- Service Bulletin -

Exx8 series Firmware update information (Main-FW & LAN-FW)

Sharp NEC Display Solutions, Ltd.
Quality Assurance Department
Quality Assurance Division
2023/March/8

E328(A): (07EV1AAJ)

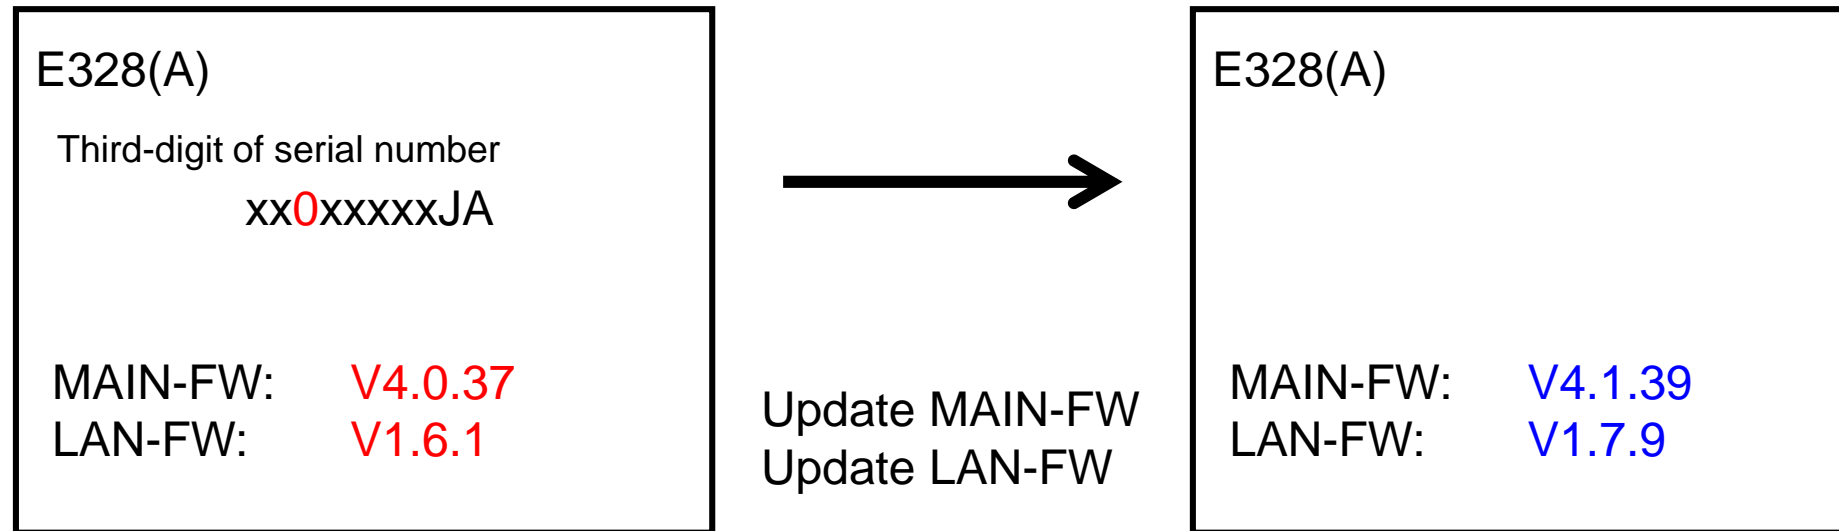
Third-digit of serial number : xx0xxxxxJA

Note: MAIN-FW and LAN-FW must be updated at the same time.

MAIN-FW : E328_TV_V4.1.39.bin

LAN-FW : ktc-s501-v1.7.9-220905.bin

E438(A): (07EW1AAJ) with 1st-O/C : H10 type

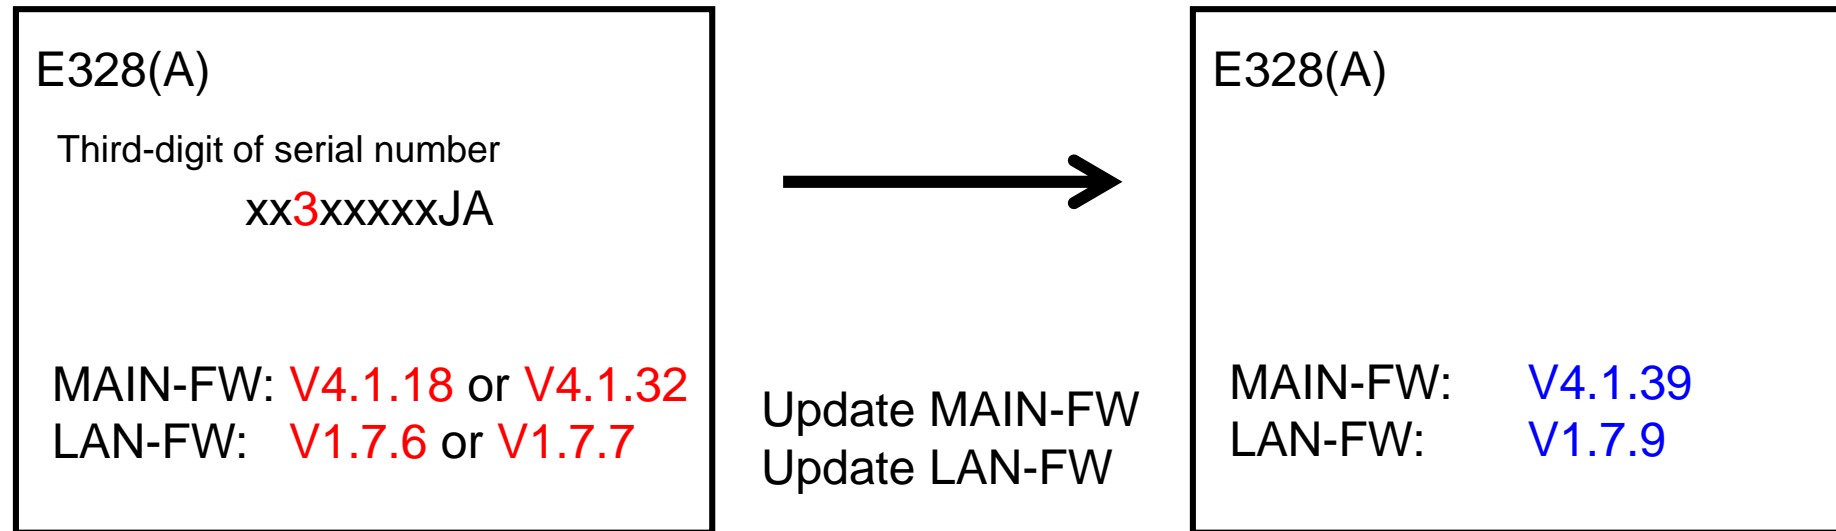
Third-digit of serial number : xx0xxxxxJA

Change LD board
Update MAIN-FW
Update LAN-FW

Note: Change Local Dimming board : V1.0.1 type at the same time.
Note: MAIN-FW and LAN-FW must be updated at the same time.

MAIN-FW : E438_TV_V4.1.40.bin

LAN-FW : ktc-s501-v1.7.9-220905.bin

E438(A): (07EW1AAJ) with 1st-O/C : H10 type

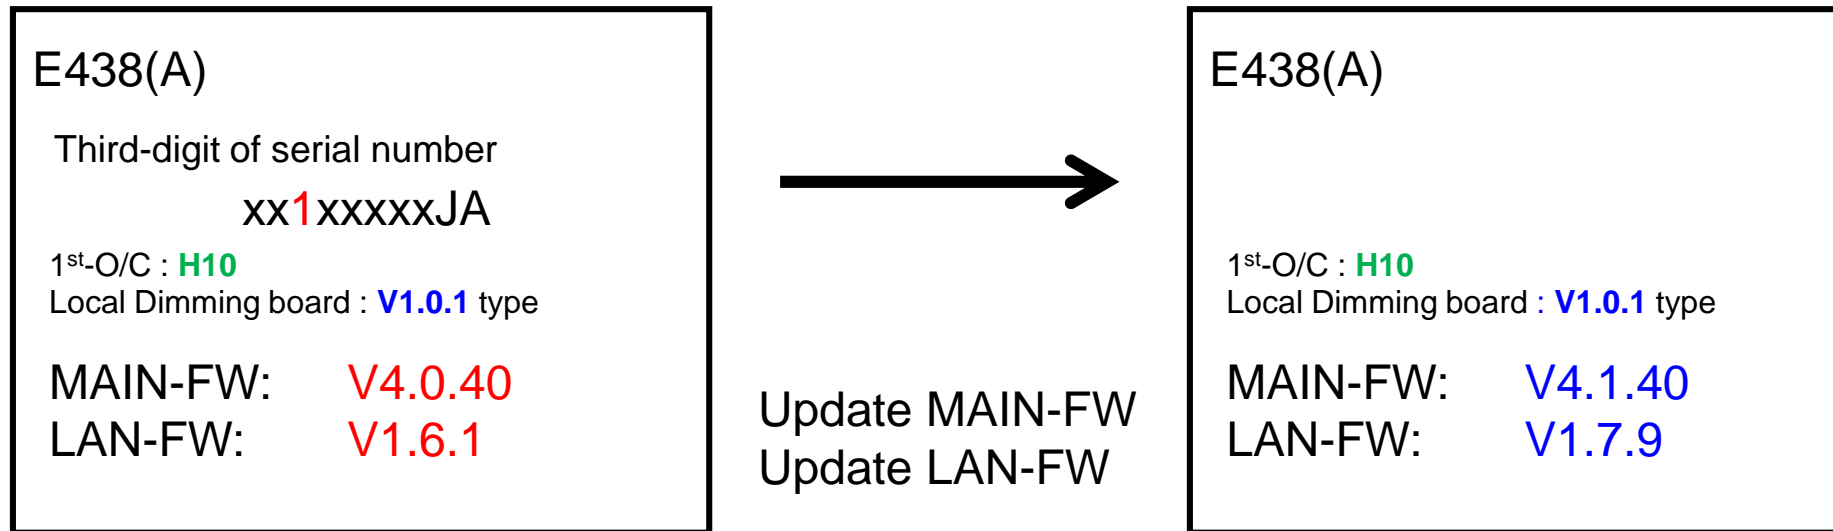
Third-digit of serial number : xx1xxxxxJA

Note: MAIN-FW and LAN-FW must be updated at the same time.

MAIN-FW : E438_TV_V4.1.40.bin

LAN-FW : ktc-s501-v1.7.9-220905.bin

E438(A): (07EW1AAJ) with 2nd -O/C : F70 type

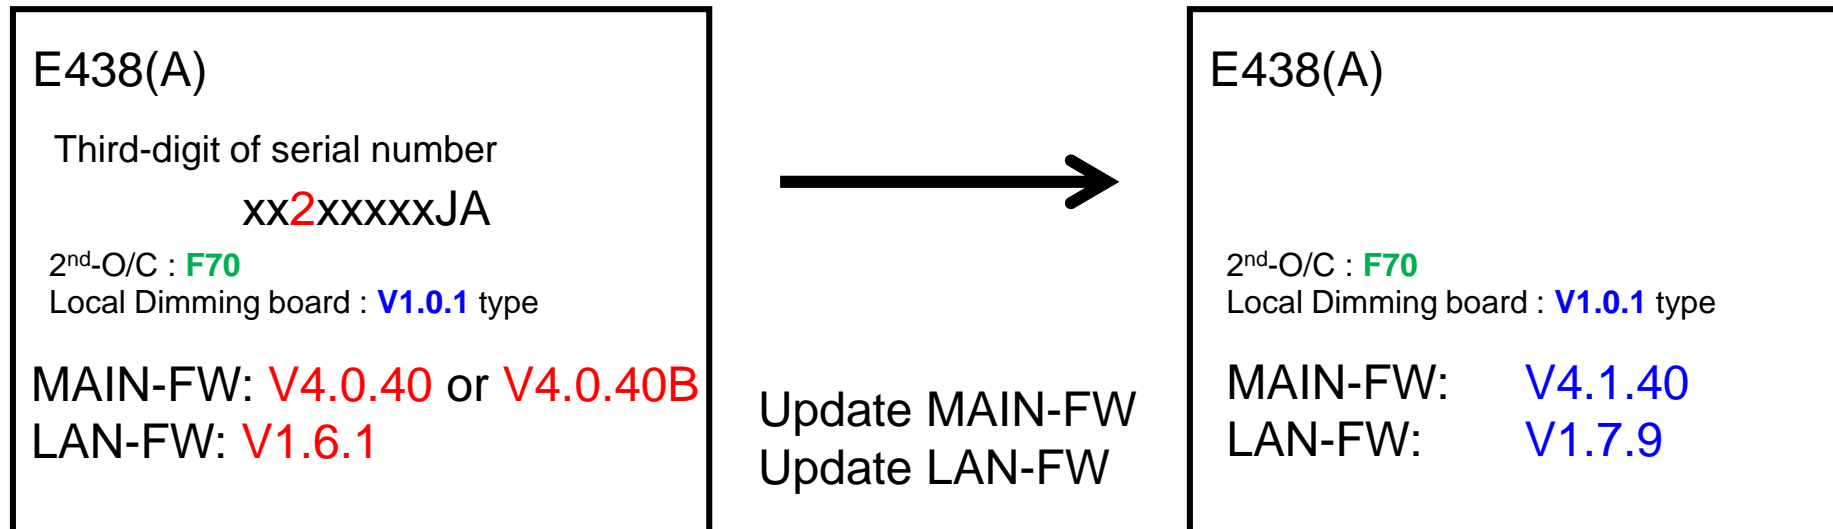
Third-digit of serial number : xx2xxxxxJA

Note: MAIN-FW and LAN-FW must be updated at the same time.

MAIN-FW : E438_TV_V4.1.40_F70.bin

LAN-FW : ktc-s501-v1.7.9-220905.bin

E438(A): (07EW1AAJ) with 2nd -O/C : F70 type

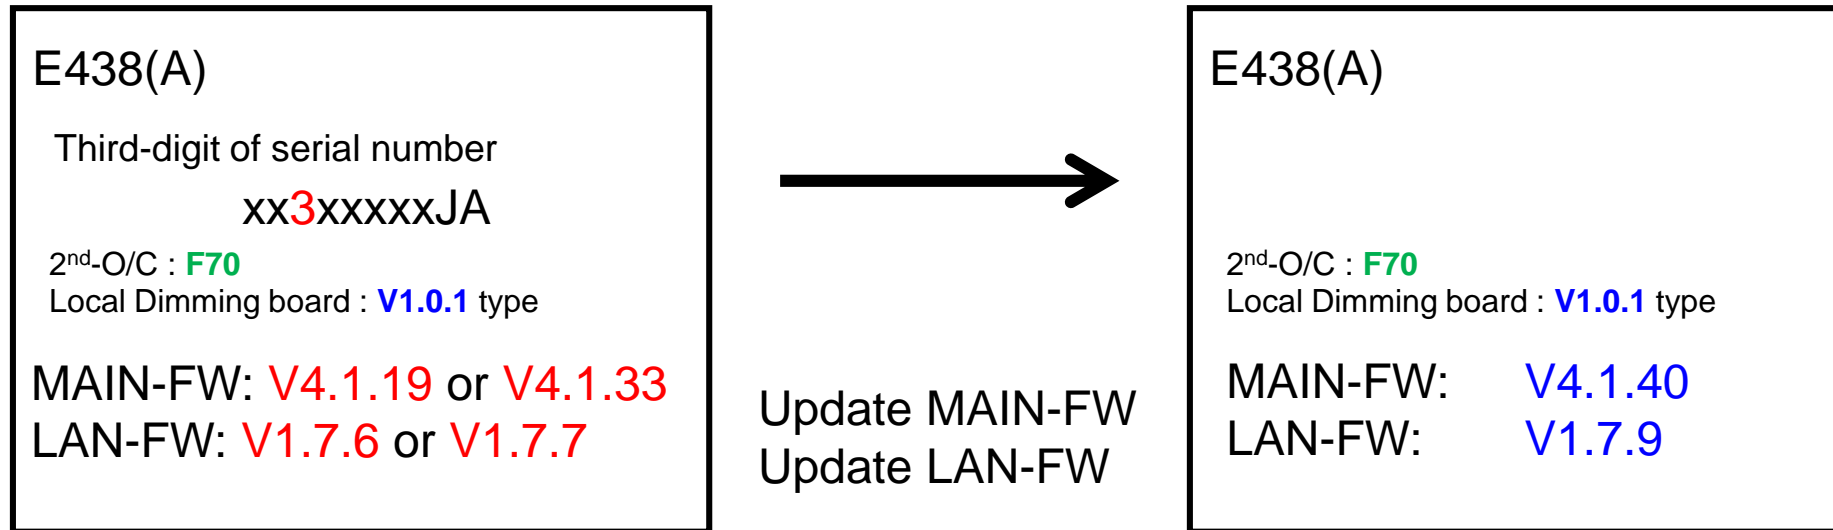
Third-digit of serial number : xx3xxxxxJA

Note: MAIN-FW and LAN-FW must be updated at the same time.

MAIN-FW : E438_TV_V4.1.40_F70.bin

LAN-FW : ktc-s501-v1.7.9-220905.bin

E498(A): (07EX1AAJ)

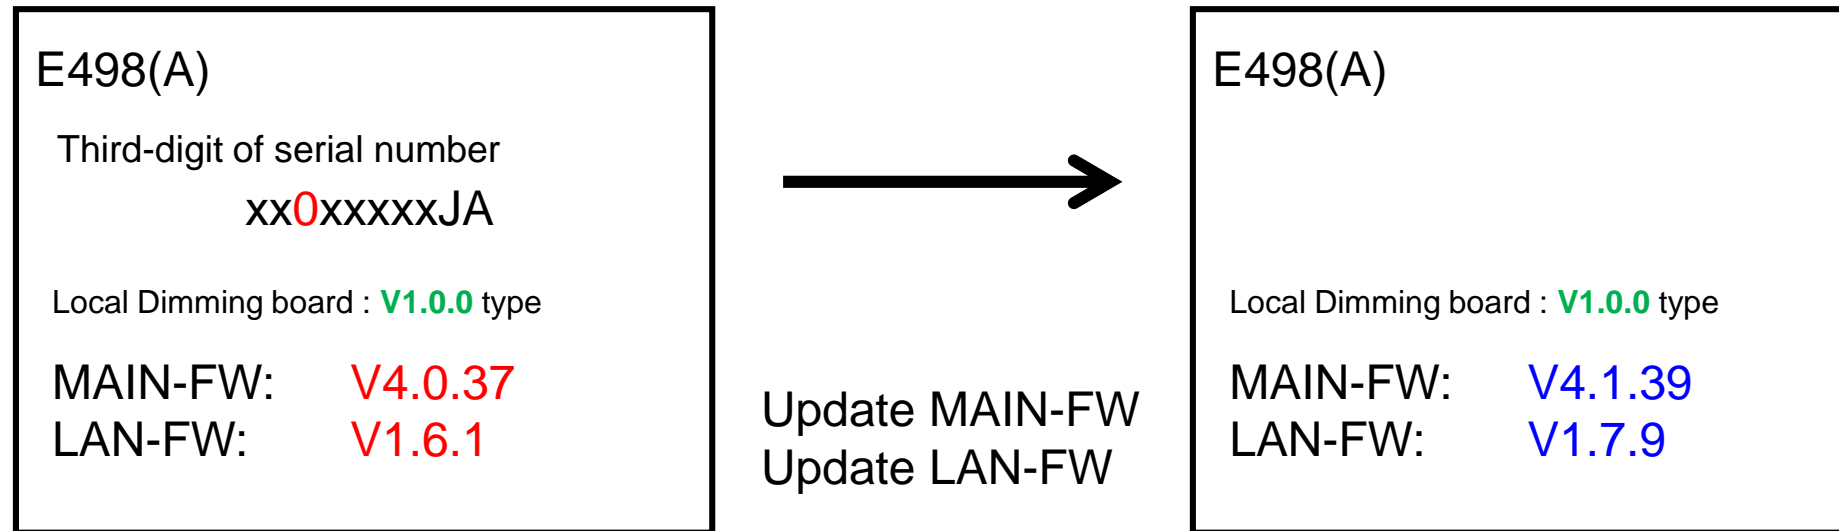
Third-digit of serial number : xx0xxxxxJA

Note: MAIN-FW and LAN-FW must be updated at the same time.

MAIN-FW : E498_TV_V4.1.39.bin

LAN-FW : ktc-s501-v1.7.9-220905.bin

E558(A): (07EY1AAJ) with 1st-O/C : 5mask type

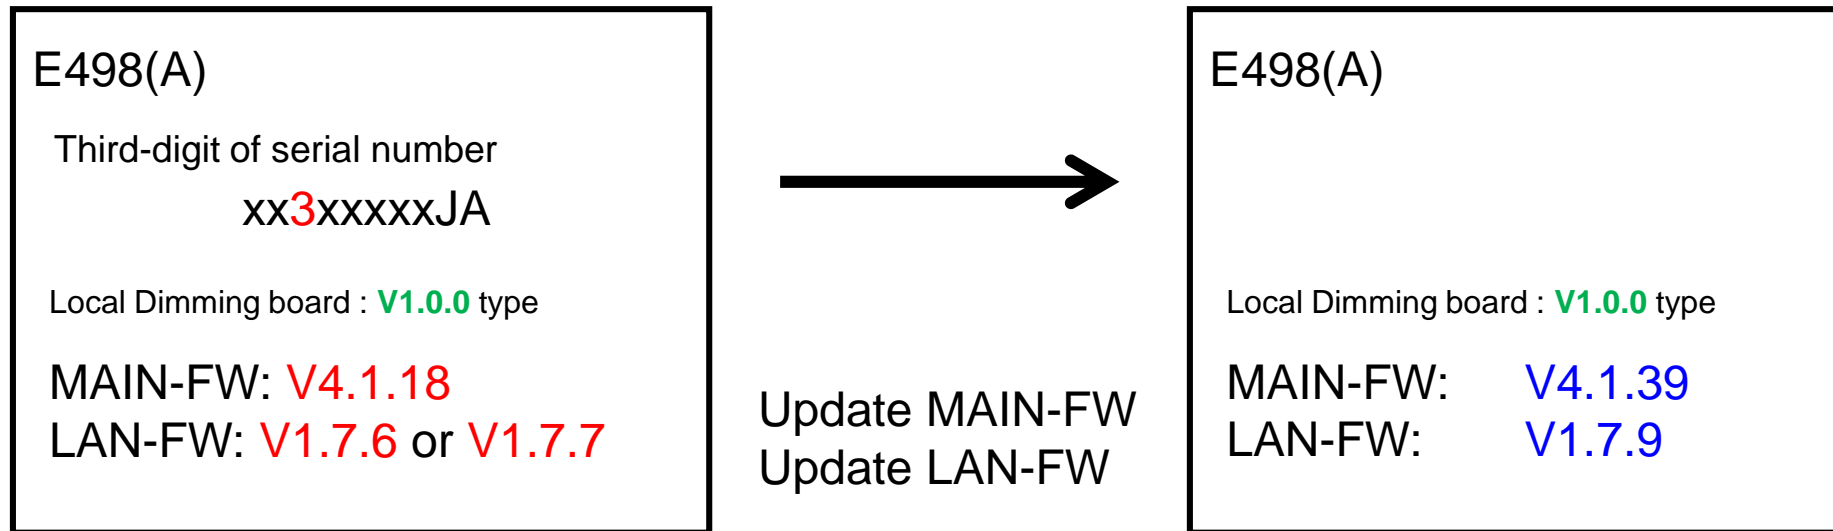
Third-digit of serial number : xx0xxxxxJA

Change LD board
Update MAIN-FW
Update LAN-FW

Note: Change Local Dimming board : V1.0.1 type at the same time.
Note: MAIN-FW and LAN-FW must be updated at the same time.

MAIN-FW : E558_TV_V4.1.40.bin

LAN-FW : ktc-s501-v1.7.9-220905.bin

E558(A): (07EY1AAJ) with 2nd -O/C : 4mask type

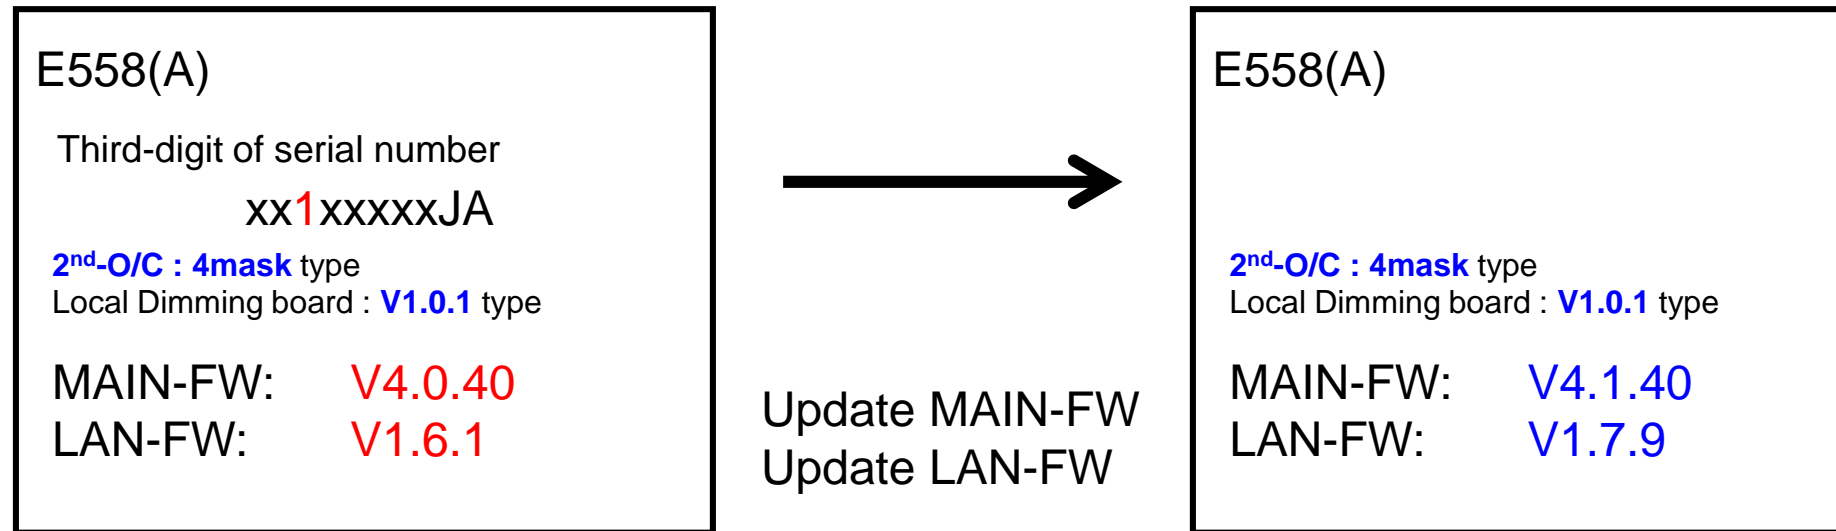
Third-digit of serial number : xx1xxxxxJA

Note: MAIN-FW and LAN-FW must be updated at the same time.

MAIN-FW : E558_TV_V4.1.40.bin

LAN-FW : ktc-s501-v1.7.9-220905.bin

E558(A): (07EY1AAJ) with 2nd -O/C : 4mask type

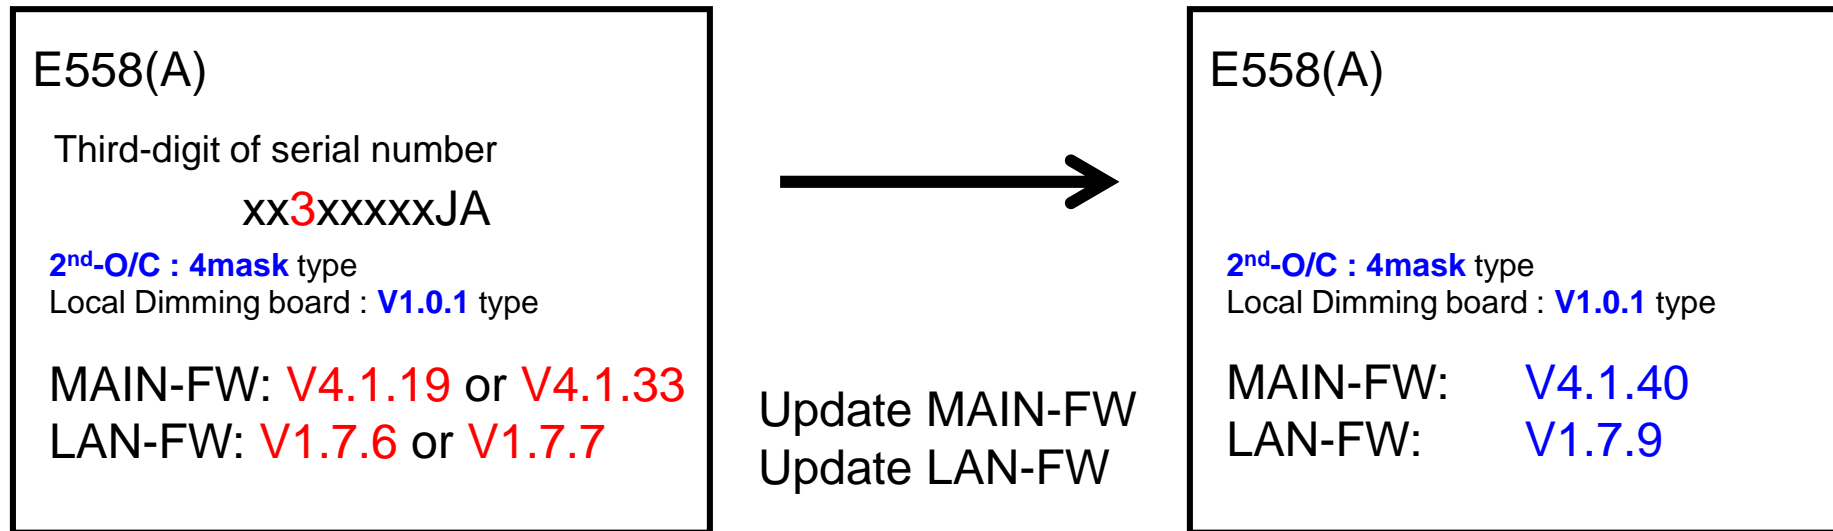
Third-digit of serial number : xx3xxxxxJA

Note: MAIN-FW and LAN-FW must be updated at the same time.

MAIN-FW : E558_TV_V4.1.40.bin

LAN-FW : ktc-s501-v1.7.9-220905.bin

E658(A): (07EZ1AAJ)

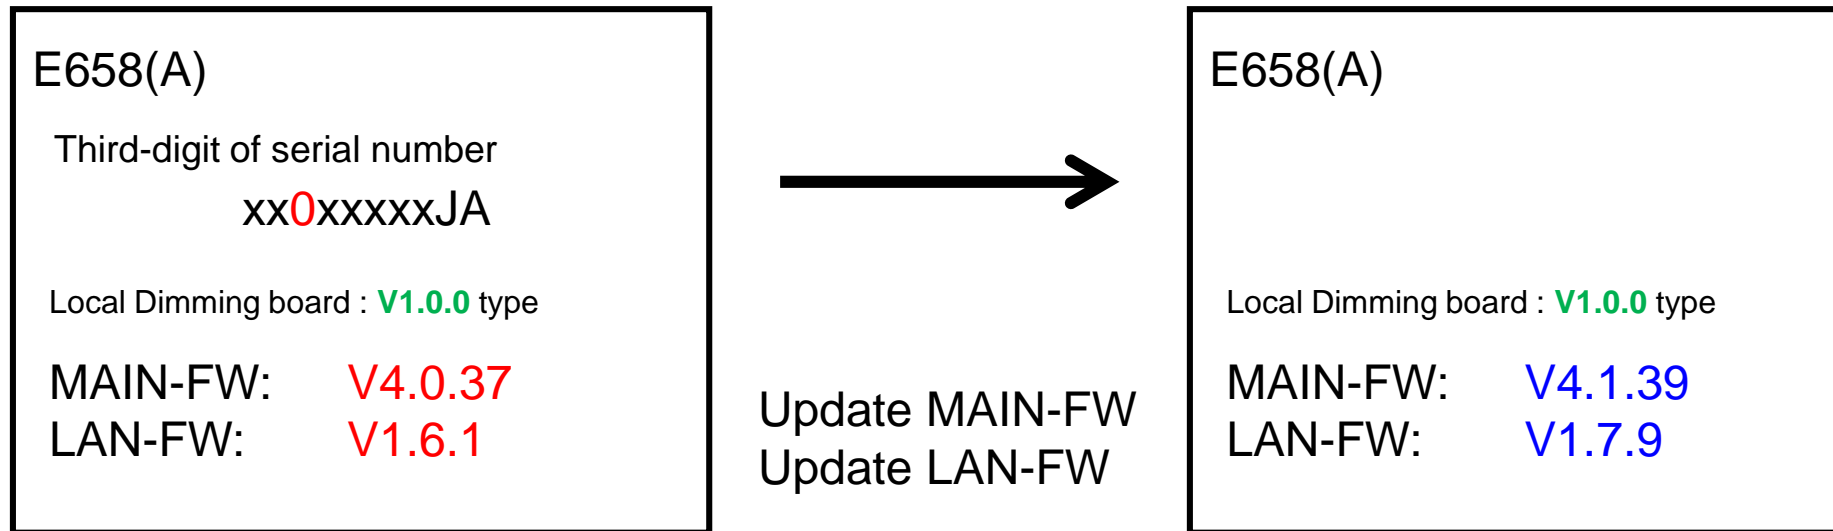
Third-digit of serial number : xx0xxxxxJA

Note: MAIN-FW and LAN-FW must be updated at the same time.

MAIN-FW : E658_TV_V4.1.39.bin

LAN-FW : ktc-s501-v1.7.9-220905.bin
